From: [Larsen, Thurman](#)
To: [Smith, Cory, EMNRD](#); [VanHorn, Kristen, NMENV](#)
Subject: C-141 Initial Report for South Carbon Canister Rupture Disk Incident on 010716
Date: Friday, January 22, 2016 3:46:31 PM
Attachments: [C141 Initial Carbon Canister Incident 010716.pdf](#)

WRG Carbon Canister
Overflow
2016 Wastewater
Form C-141
Revised August 8, 2011

Release Notification and Corrective Action

Please answer these questions to the best of your ability:

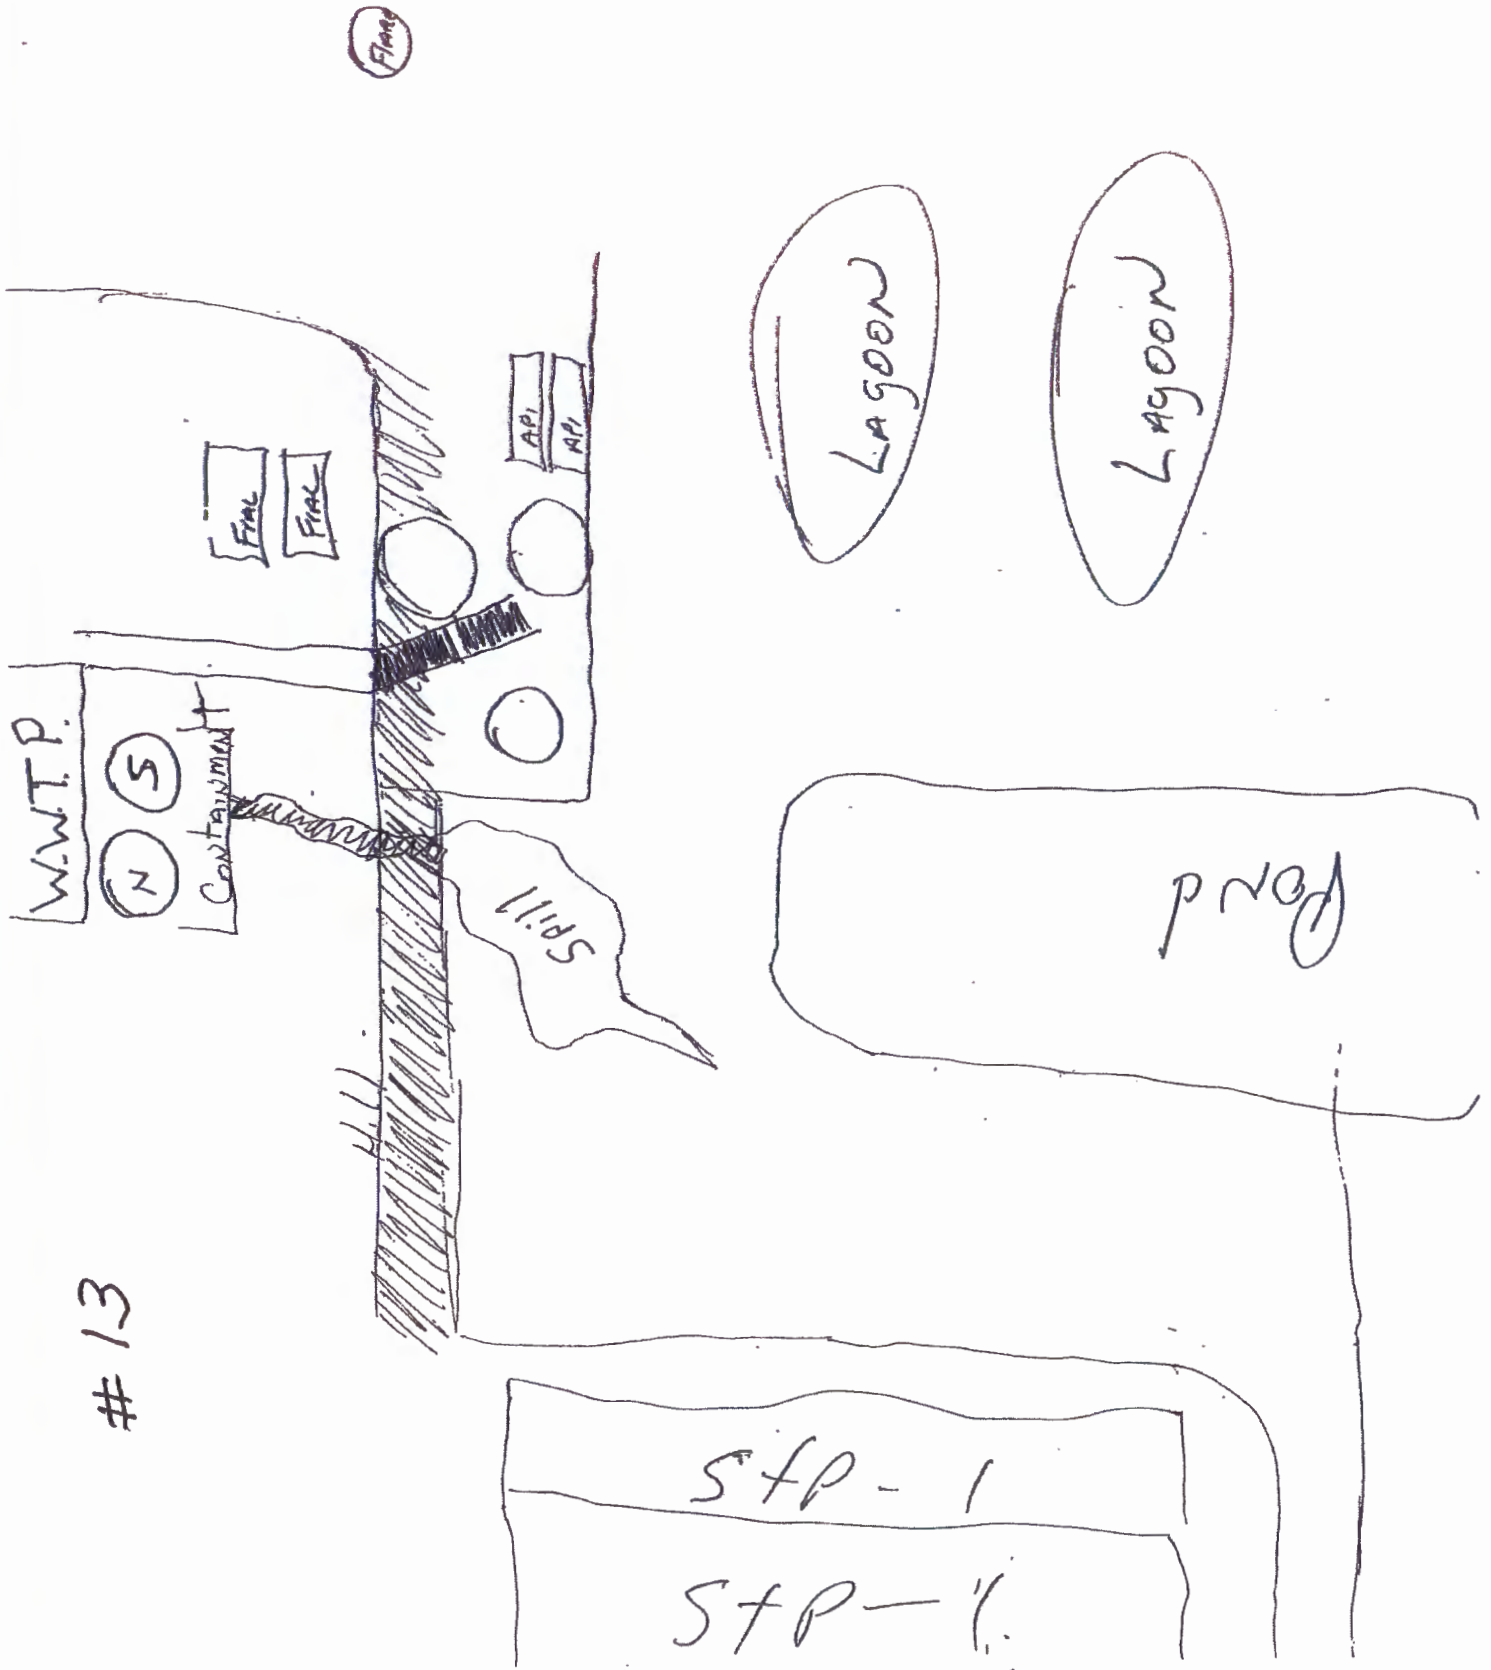
13. Send a figure of the site with the location of the release and the extent of water flow and the locations of pooled water sketched on the figure. **See attached**

12. Where did the wastewater flow? **The water flowed into a small earthen containment area around the carbon canisters. When the containment became full, it overflowed and ran down the hill.**
